CITY OF WEST LAKE HILLS, TEXAS
NOTICE OF ZONING & PLANNING COMMISSION (ZAPCO) REGULAR MEETING
Wednesday, October 21, 2020 at 6:30 PM

CITY OF WEST LAKE HILLS, TEXAS
MINUTES OF A ZONING & PLANNING COMMISSION (ZAPCO) REGULAR MEETING
Wednesday, September 16, 2020 at 6:30 PM

Doucet & Associates, Inc. (Doucet), is pleased to submit this response letter to our September 29, 2020 engineering drainage report documenting the analysis of a partial easement release located at 2 Downie Place in West Lake Hills, Texas. Our response to Comments 3-8 are as follows in blue text.

Cross Section 3 (DEVELOPED)

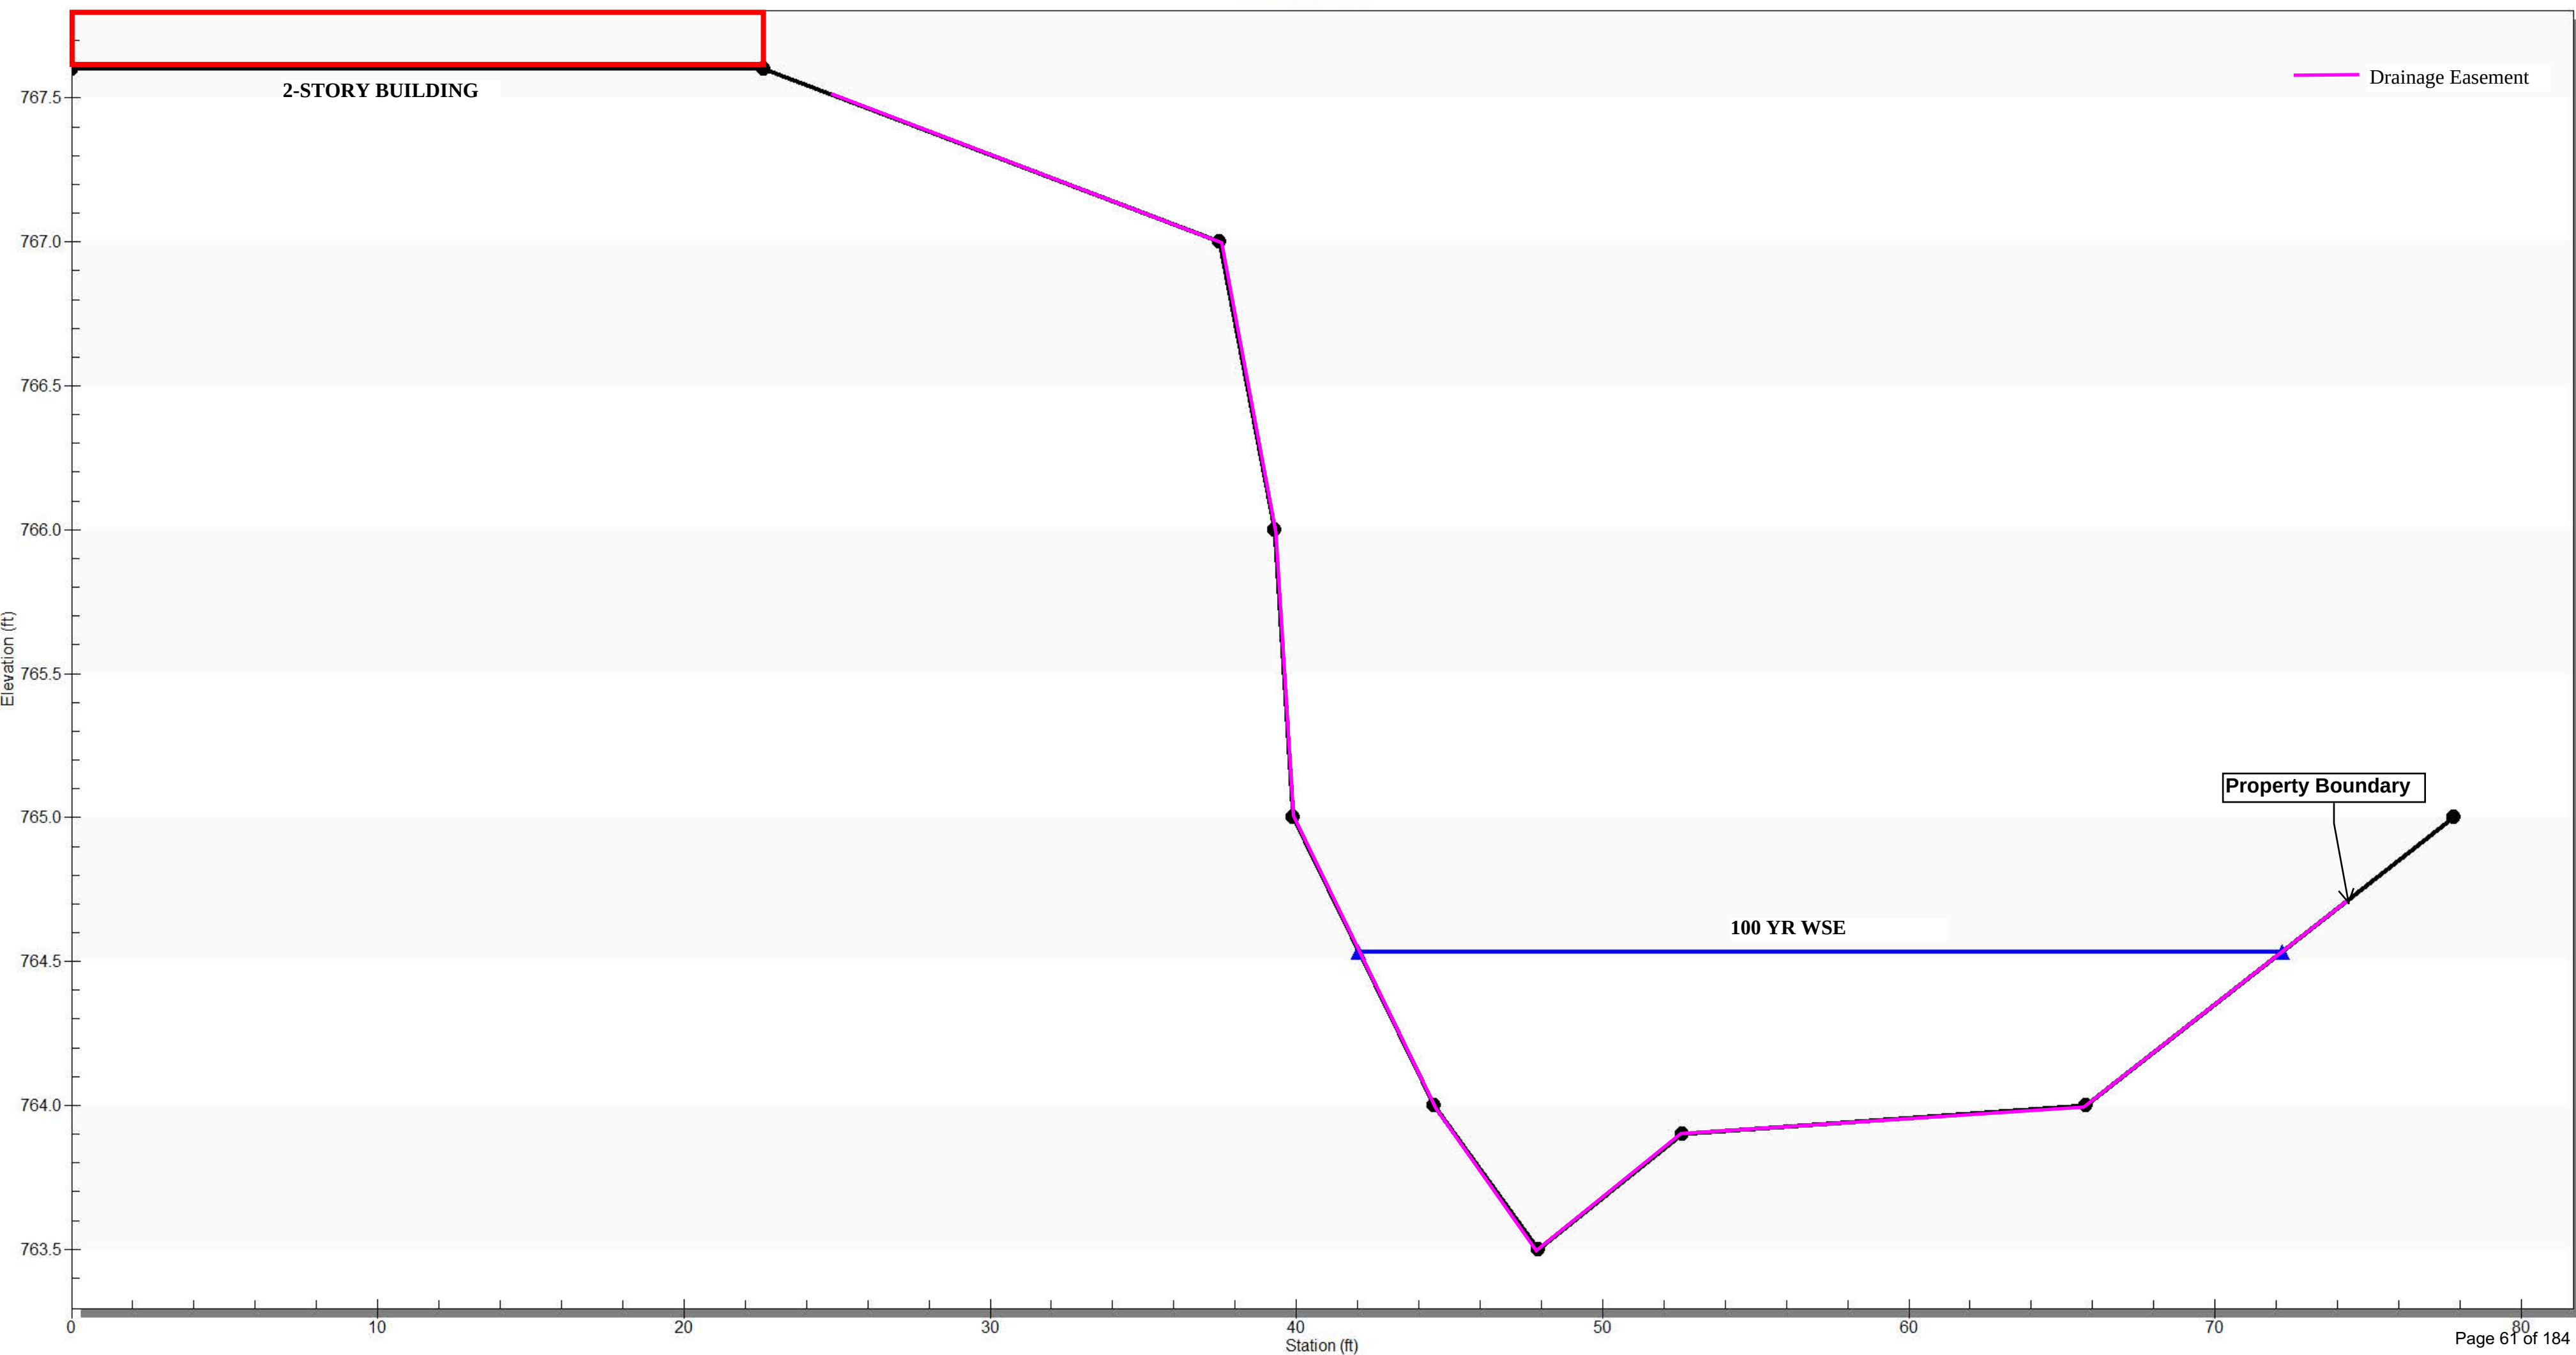
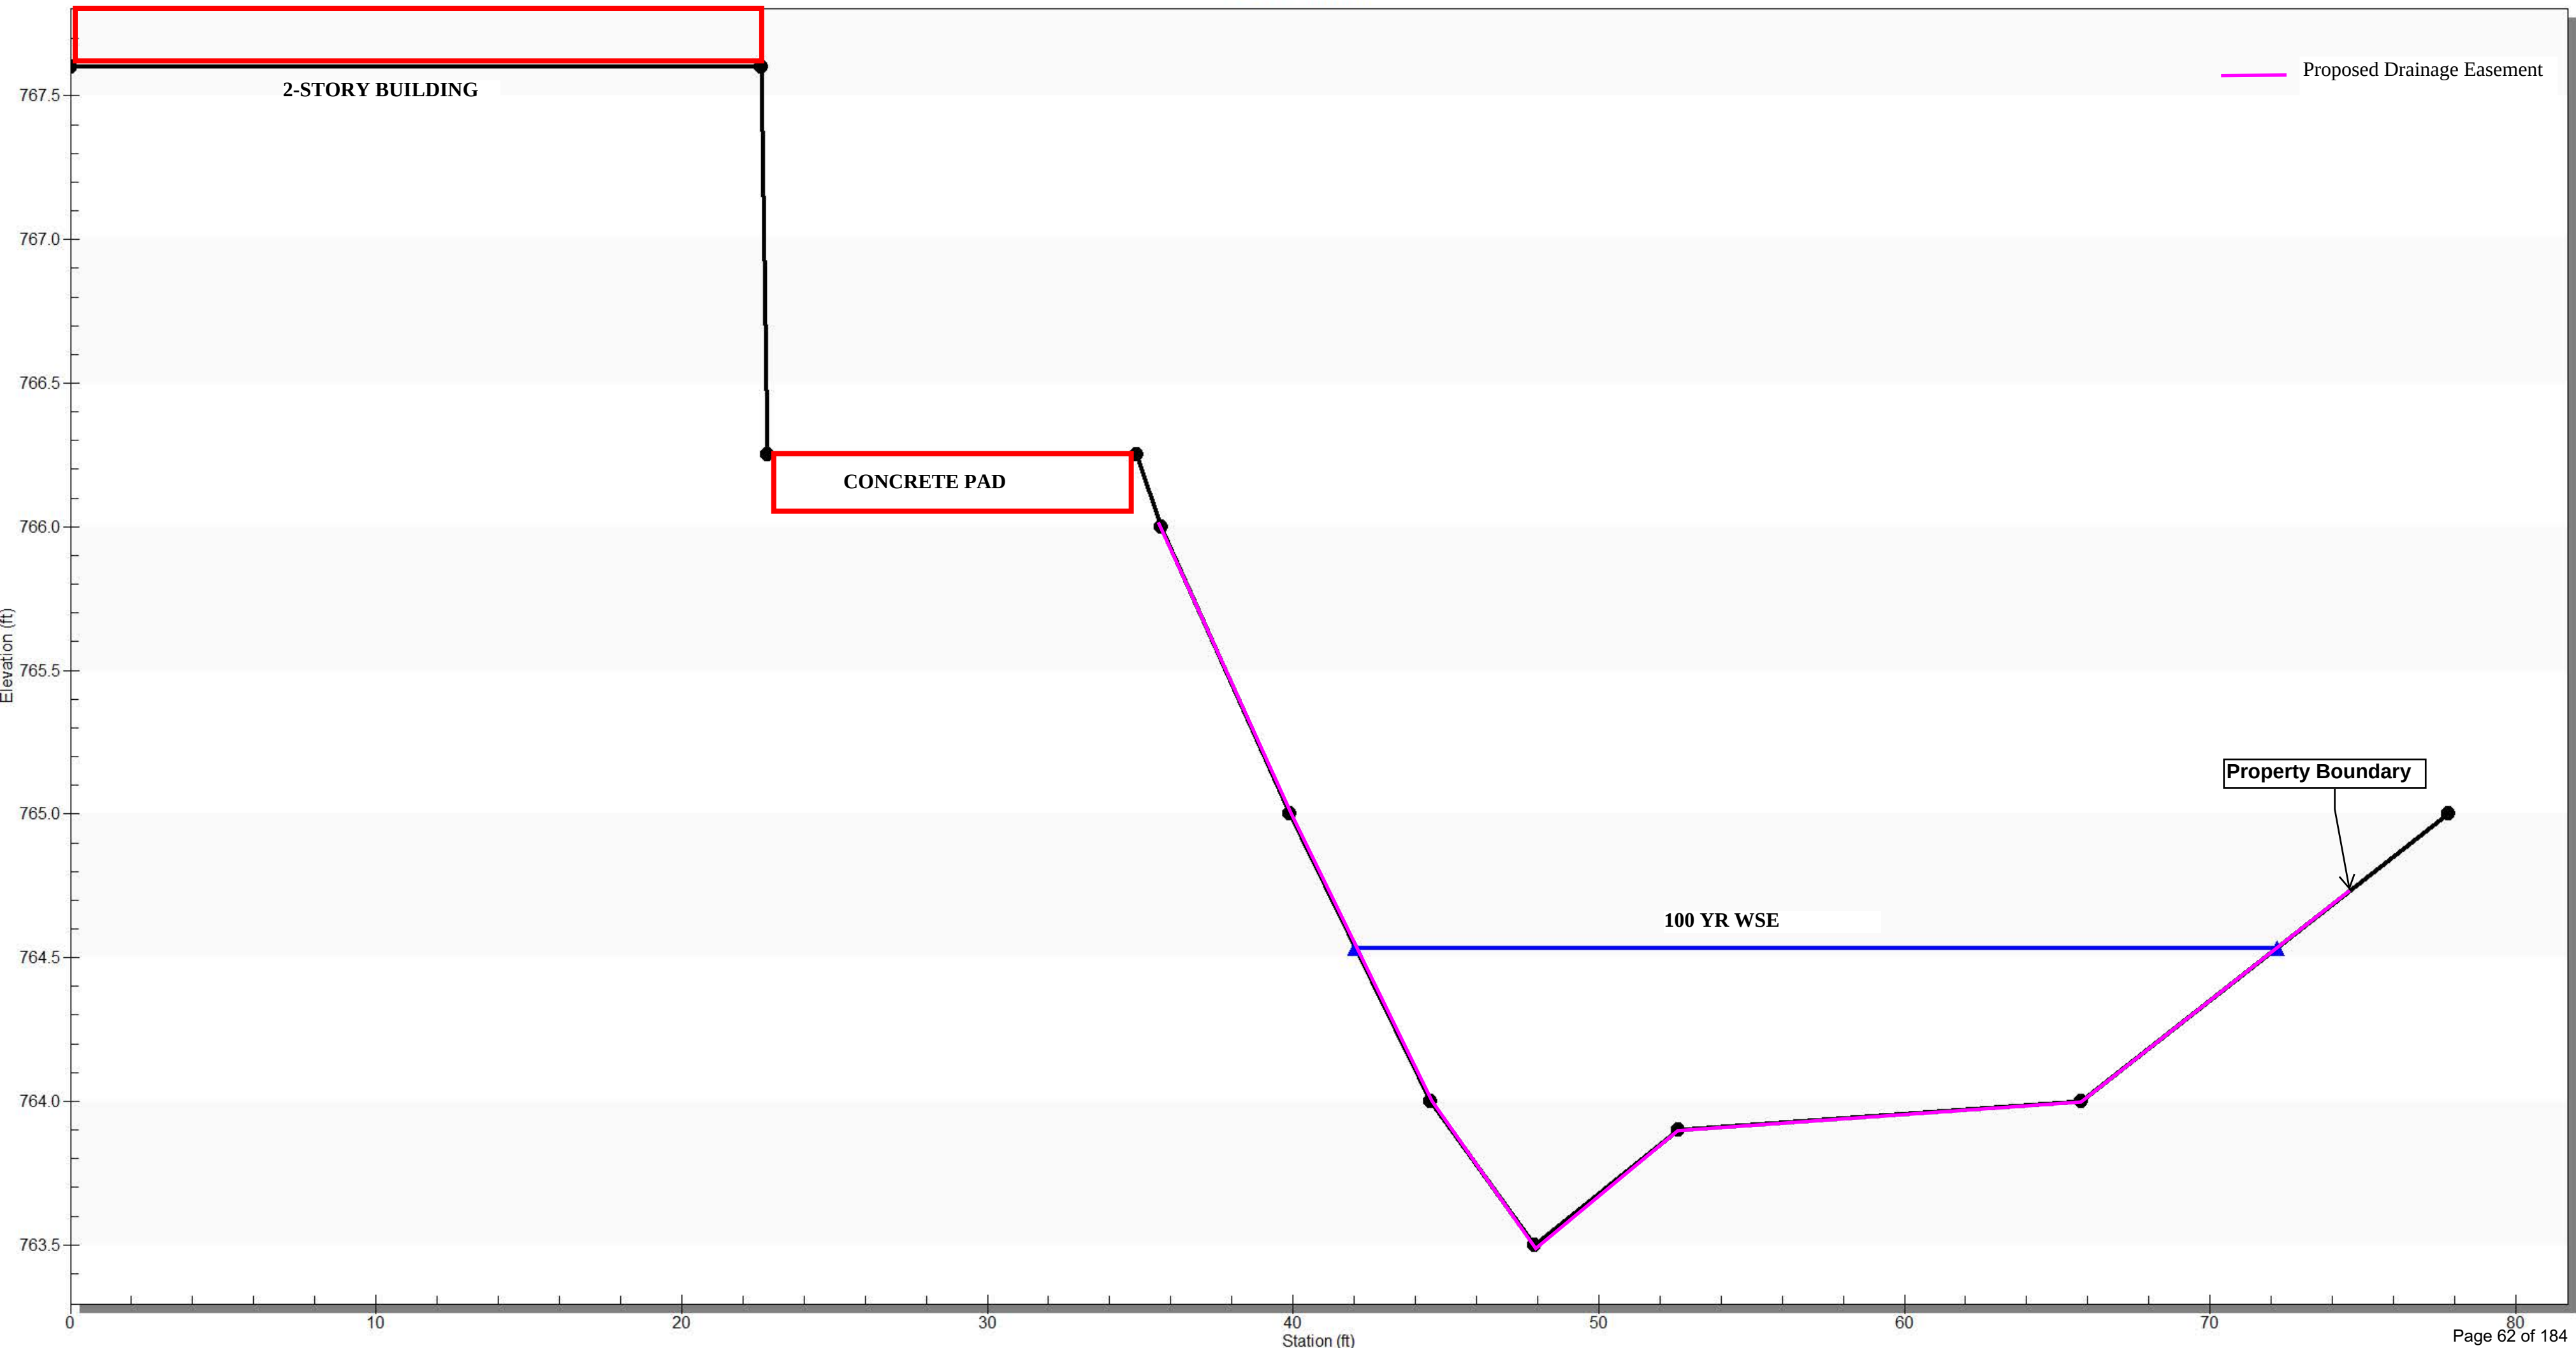
3-C1) Please show property line, existing, and proposed easement line in the cross section to verify overtopping elevations.

7-C1) Please show property line, existing easement line, and proposed easement line in the cross sections.

Response: Easement lines and property boundary has been added to cross sections.

Response: Easement lines and property boundary has been added to cross sections.
